Lower Thames Crossing

9.117 Applicant's Comments on IP submissions at Deadline 1 to 3

DATE: October 2023
DEADLINE: 5

Planning Inspectorate Scheme Ref: TR010032
Examination Document Ref: TR010032/EXAM/9.117

Plate 2.1 Extract from LTAM SATURN cordon model (2045 AM peak)

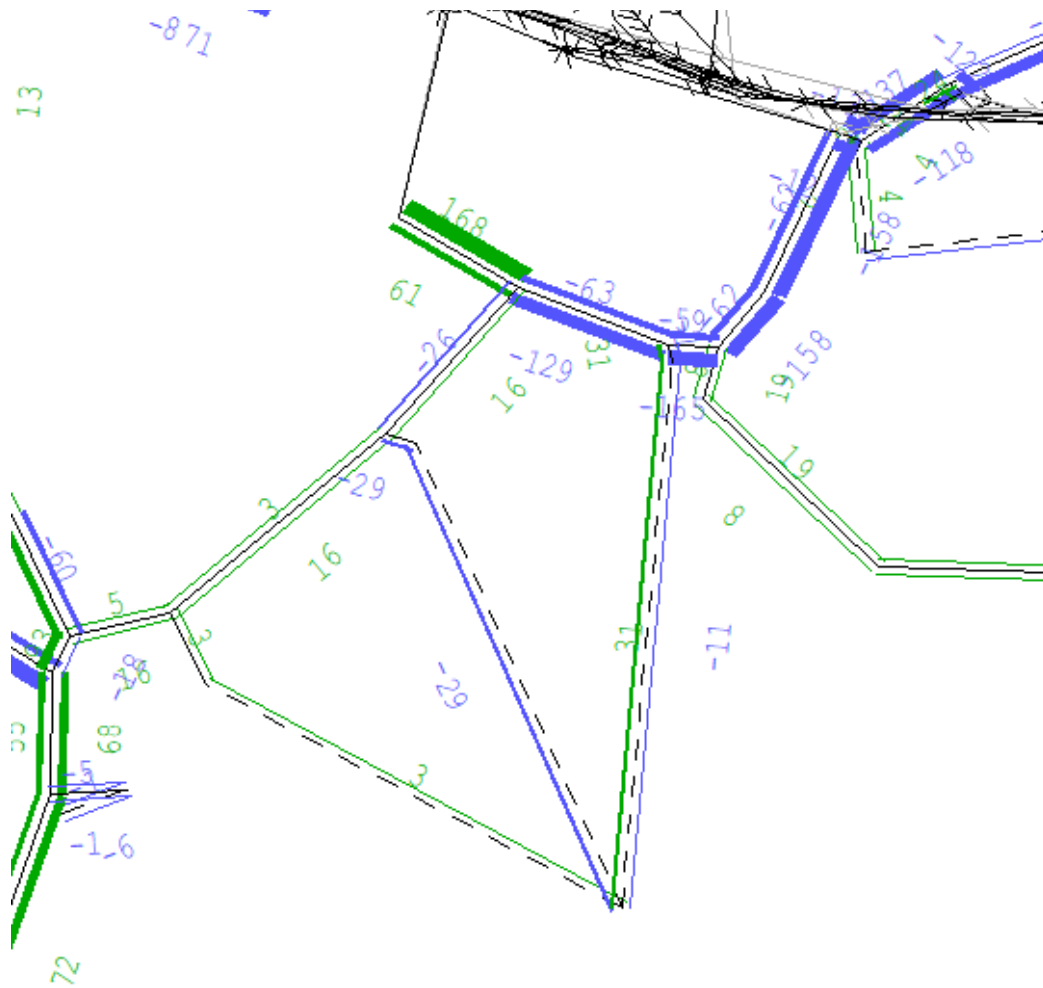
2.1.3 Gravesham Borough Council provided a Local Road Traffic Impacts report [\[REP1-230\]](#) as part of its LIR. This document included the following comment (paragraph 19):

'Southbound LTC does not seem to make much difference, but northbound there is a decrease. It has not been explored in detail but at first sight the flow on Henhurst Road does not seem to sit well with the flows on Sole Street and The Street.'

2.1.4 In response to this comment, the Applicant has reviewed the Lower Thames Area Model (LTAM) SATURN cordon model that was provided to Gravesham Borough Council. It shows that the decrease on Sole Street and increase in Henhurst Road which '*does not seem to sit well*' is due to a small re-routing change in the centroid connectors used from the local traffic zone that loads local traffic from Sole Street and Cobham onto the network. This effect would not be apparent from the GIS shapefiles but is shown in the LTAM SATURN model. The number of vehicles involved in the re-routing is very low. As shown in the extract from LTAM in Plate 2.1 below, with the Project, 29 trips switch from loading onto the network at Sole Street to go northbound and instead are loaded onto the network on The Street and go northbound along Henhurst Road.

Figure 2.1 Extract from Thurrock Council's LIR Appendix C: Transport and Modelling [REP1-284], Figure 9-1 Analysed Thurrock Model Journey Time Routes

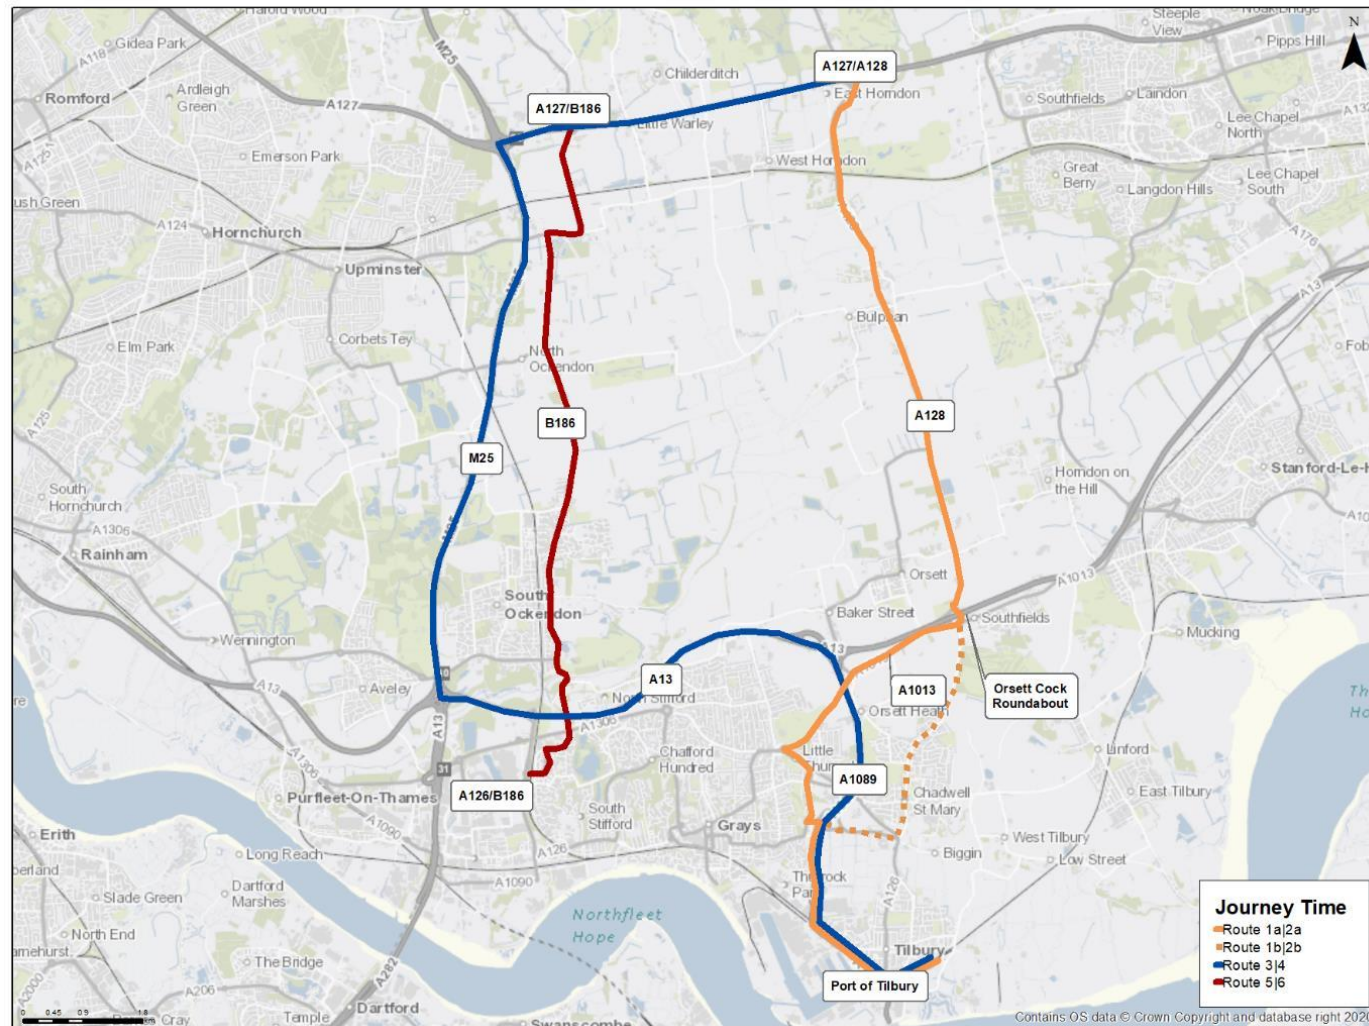
C3.2.6	<p>The analysis of journey times predicts increases of up to four minutes dependent on route and time period. It is evident that the construction activities are predicted to result in significant journey time increases on key routes in Thurrock including those routes leading to Port of Tilbury. Given that the LTAM strategic model, represents average conditions in the modelled hour, journey time increases for some vehicles are likely to be significantly higher than those suggested by the strategic model.</p>	<p>Paragraph C3.2.6 highlights journey time '<i>increases of up to four minutes</i>' for routes leading to the Port of Tilbury during the construction period. This is a correct interpretation of the LTAM, but it is also true to say that for most routes analysed the increase is less than two minutes, and for some it is less than 30 seconds or a journey time decrease. The data upon which this paragraph relies is in Table 9-1 and Table 9-2 of Sub-Annex 3.1 of LIR Appendix C. For ease of reference, the map of journey time routes from Figure 9-1 of Sub-Annex 3.1 of LIR Appendix C have been reproduced below.</p> <p>The PM peak does not have any forecast increases above three minutes, and in the AM peak there would be</p>

LIR Appendix C: Transport and Modelling Section	Thurrock Council Comments	Applicant's Comments
		<p>only two routes out of the eight assessed where the journey time increases by the four minutes stated by Thurrock Council. These are: route 1a, which is southbound via the A128 and A1013; and route 3, which is southbound via the A127, M25, A13, and A1089. The stated four minute increase for route 1a only occurs during a single construction phase (phase 5, which is five months long). The increase for route 3 occurs across phases 5, 4, and 6 (a total period of 15 months). It is again emphasised from paragraph 8.1.7 of the Transport Assessment [REP4-150] that the LTAM has been designed to capture the worst-case impacts as much as possible.</p>

Appendix A Receptors and Model Verification Zones

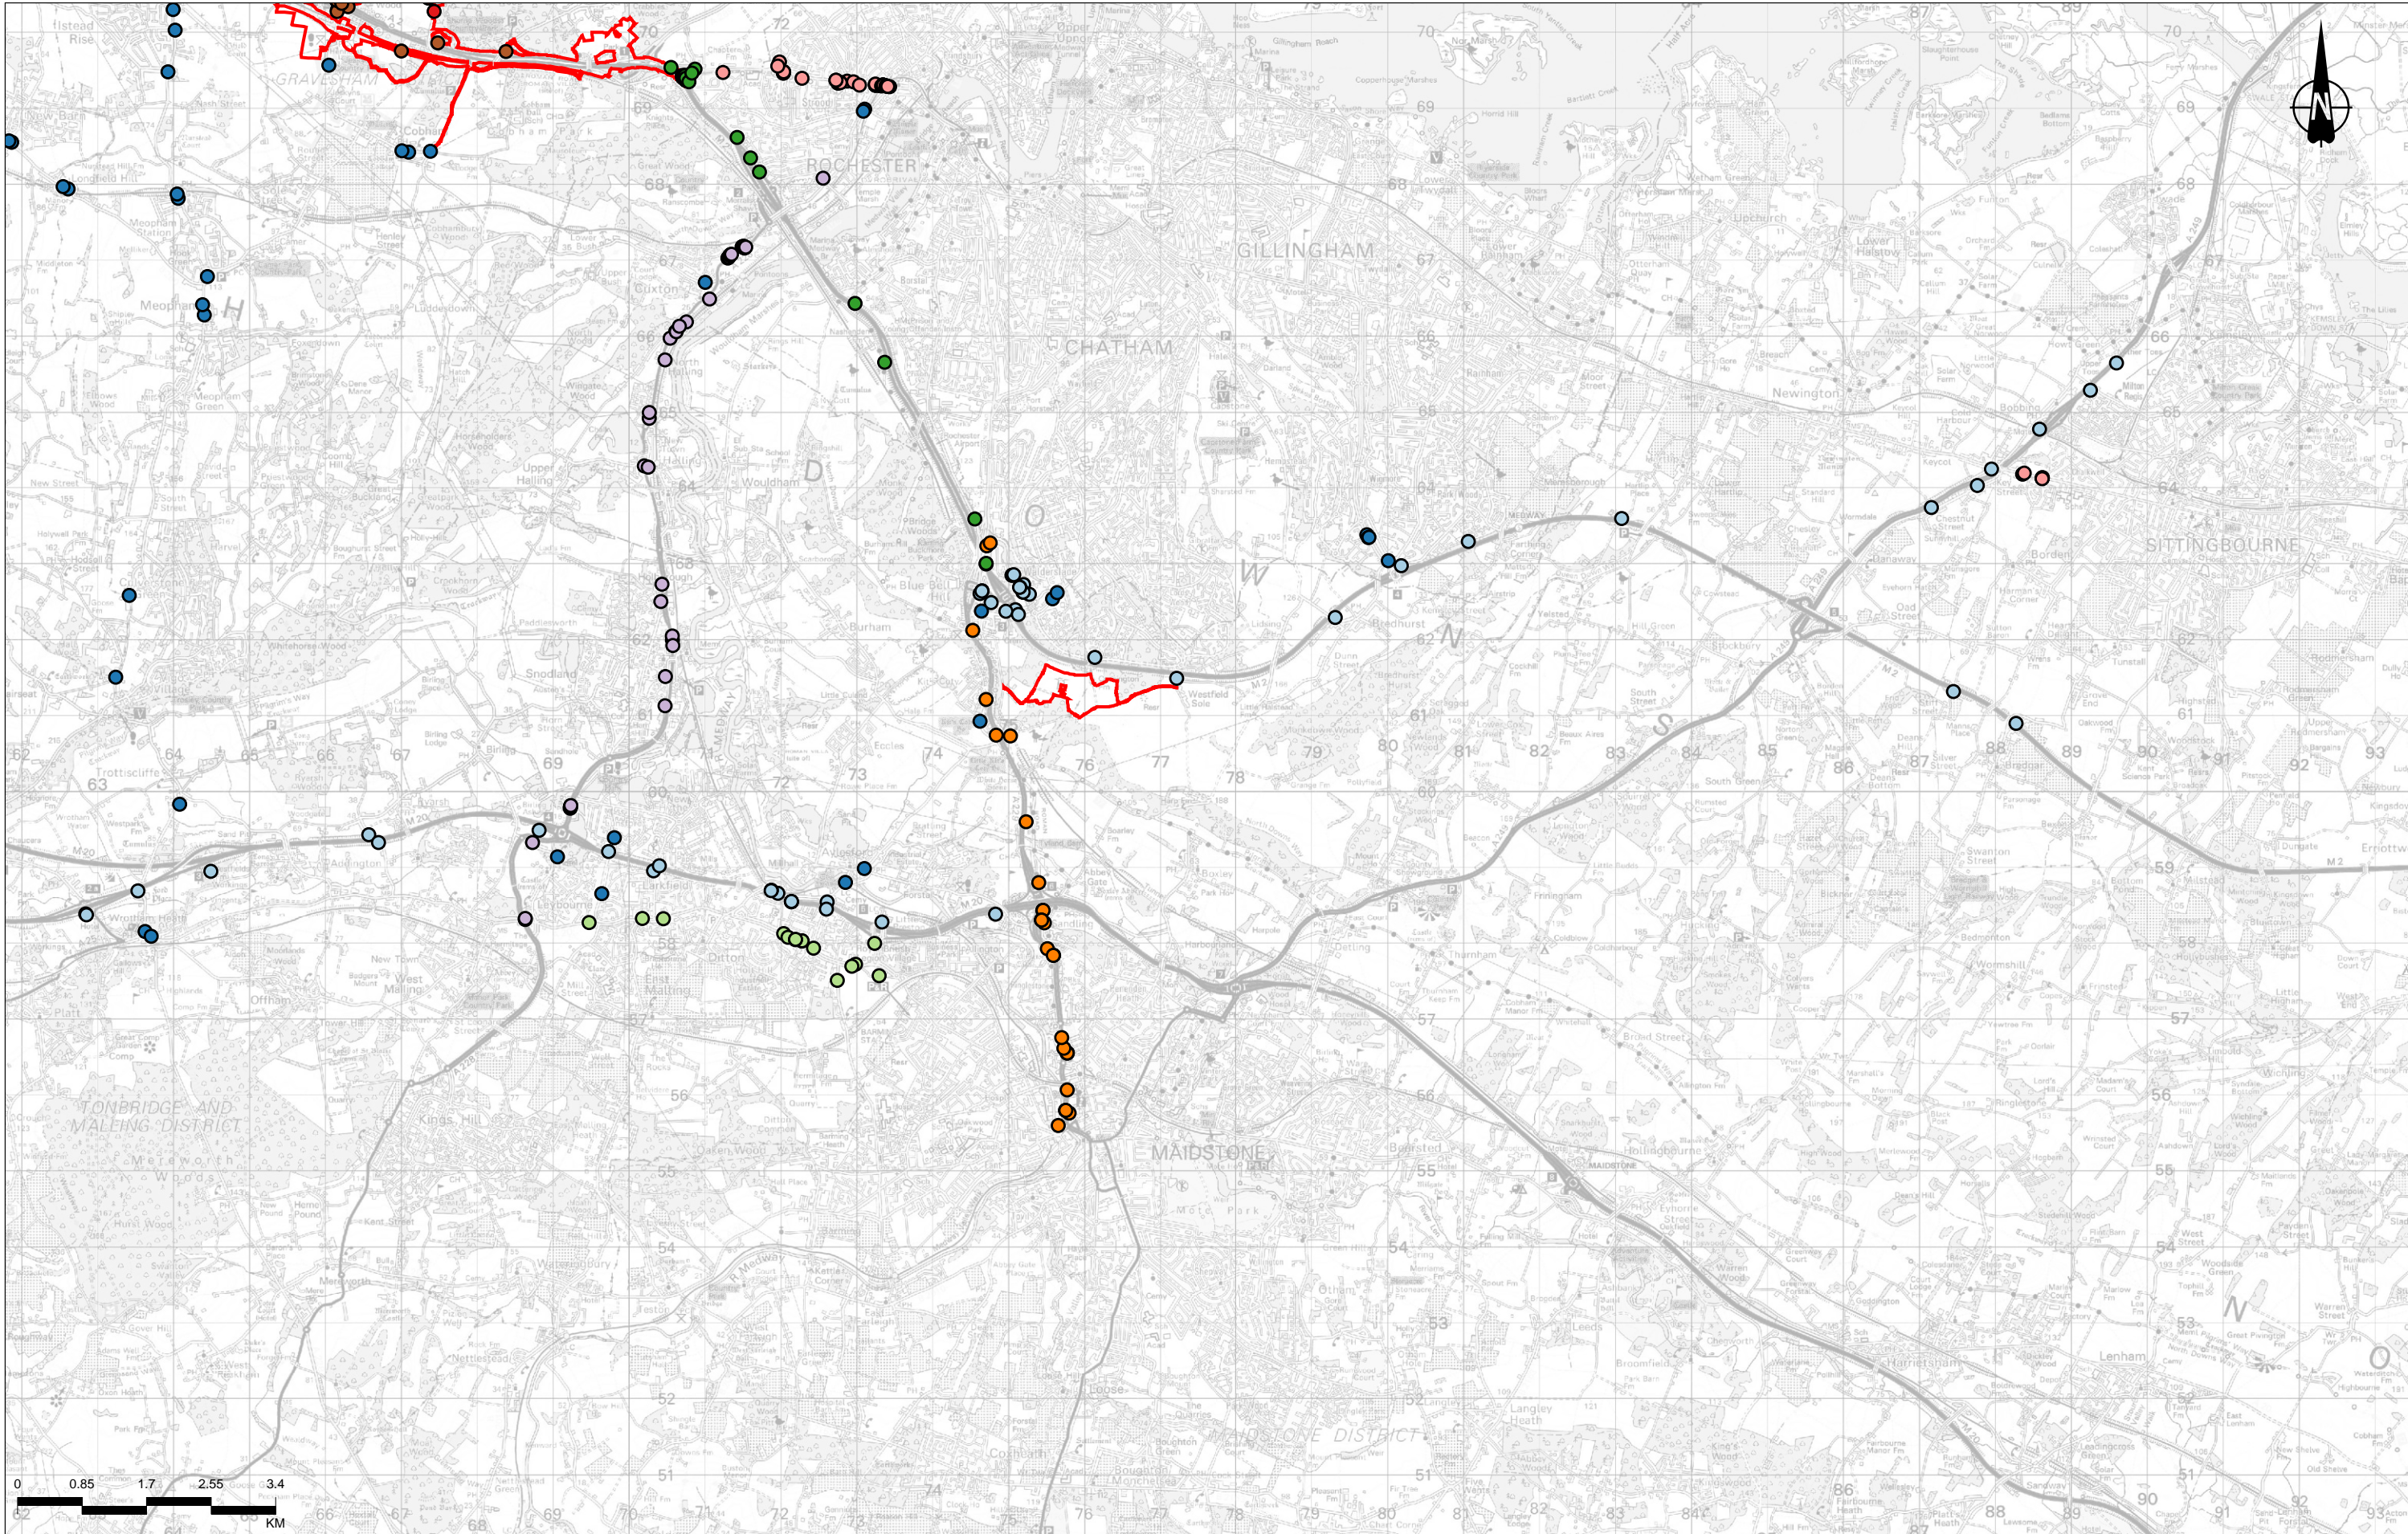
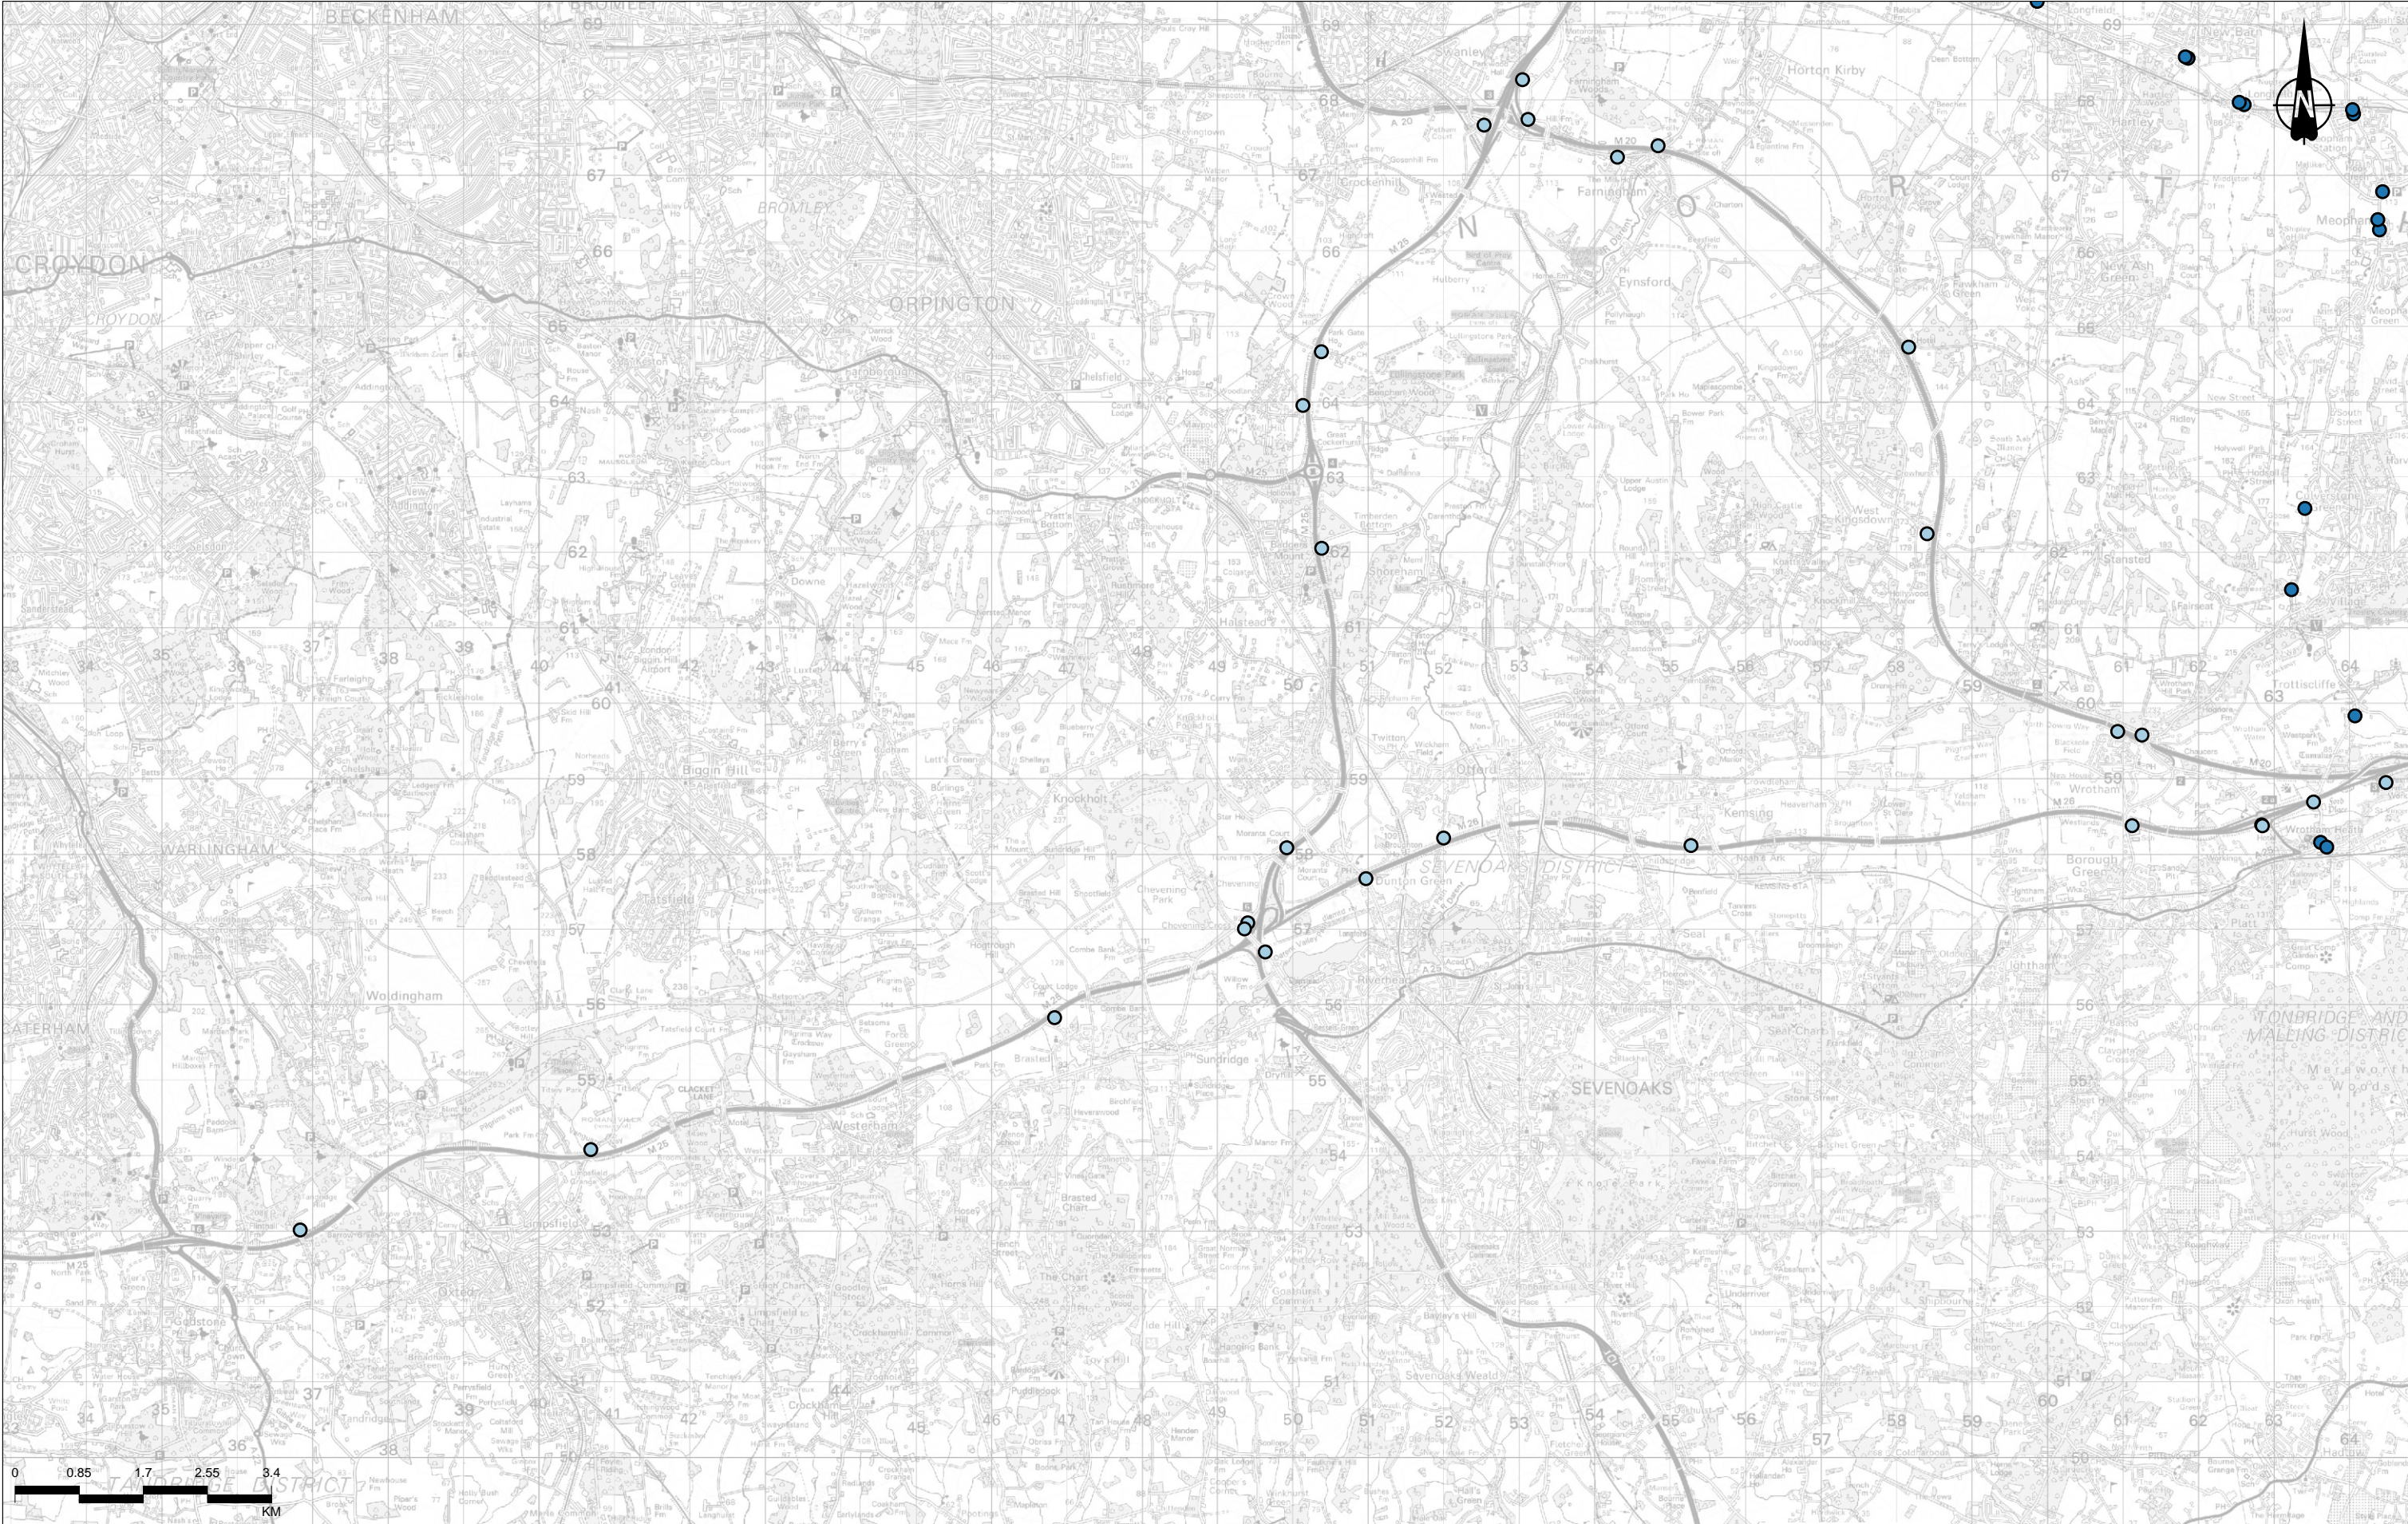
Section/Ref	Thurrock Council's comments on submissions at D1 and D2	Applicant's response
Section 18.9 – Assessment of Environmental and Health Impacts Air Quality	<p>18.9.1 The applicant's response (REP2-064) does not provide any additional information beyond that already presented in the ES Chapter 5 (APP-143) and associated appendices. This lack of engagement is disappointing and is illustrated by the response to the request within Section 10.2 of the Councils' LIR (REP1-281) for a simple figure (which the applicant will already have within their modelling) to understand the verification factors applied within the operational modelling assessment. As these factors range from 0.41 to >4 they will have a material impact upon the reported impacts at each receptor and could easily be clarified by the applicant to resolve a simple and key request.</p> <p>18.9.2 The Council therefore maintains the position that a Figure should be provided which shows where each zone has been applied and therefore which receptors are in each verification zone to better understand the reported predicted changes in air quality within the Borough (and indeed across the Study Area).</p>	<p>The Applicant has considered Thurrock Council's request in paragraphs 18.9.1 and 18.9.2 and has produced a receptors and model verification zones figure. This figure is presented in Appendix A.</p>
